To: Bidders for the Trail of Tears Phase 2

RE: Trail of Tears Phase 2
Addendum Number 1 to the October 27, 2017 Bid Document

SPEC SHEET : 166-1080

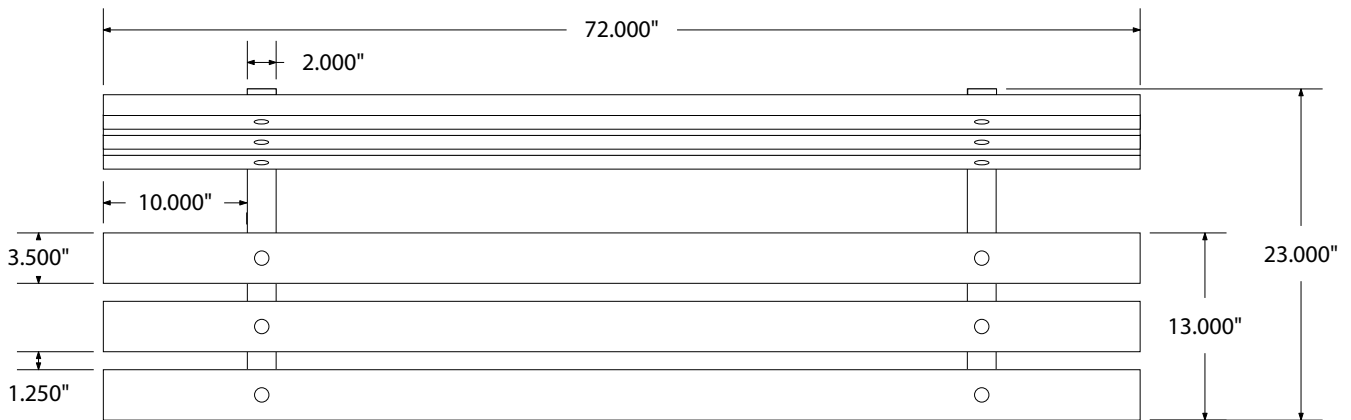
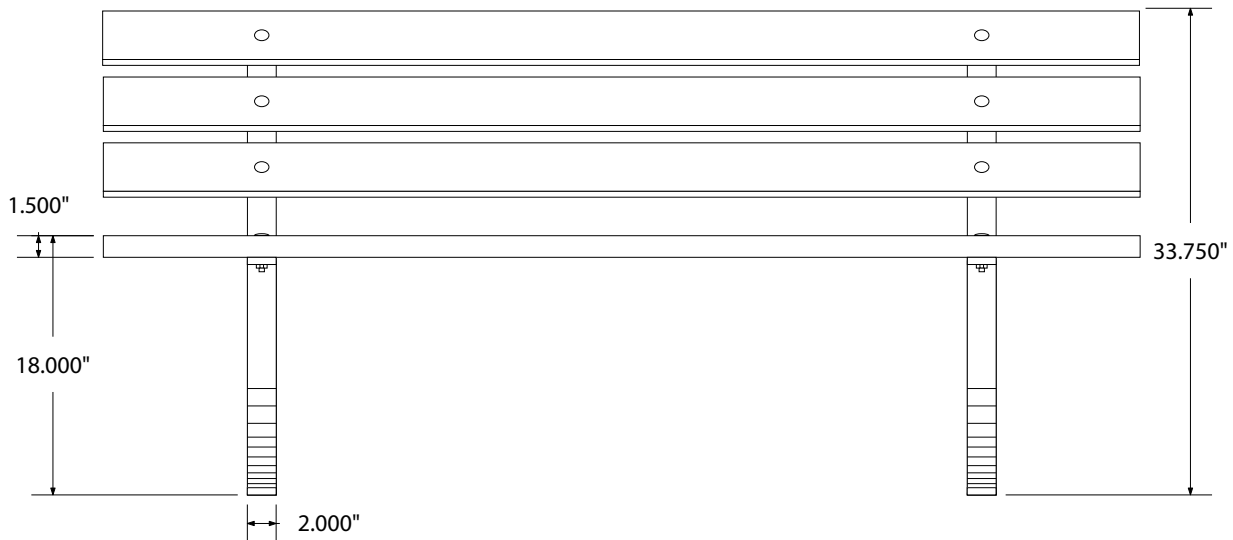
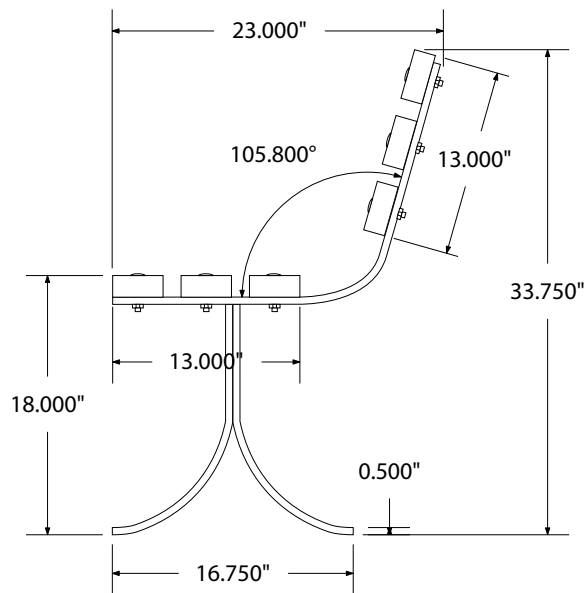
9. Question: "What is the specification for the bench shown on 2/CD-01?"

Response: See attached bench specification. Contractor shall provide same or approved equivalent.
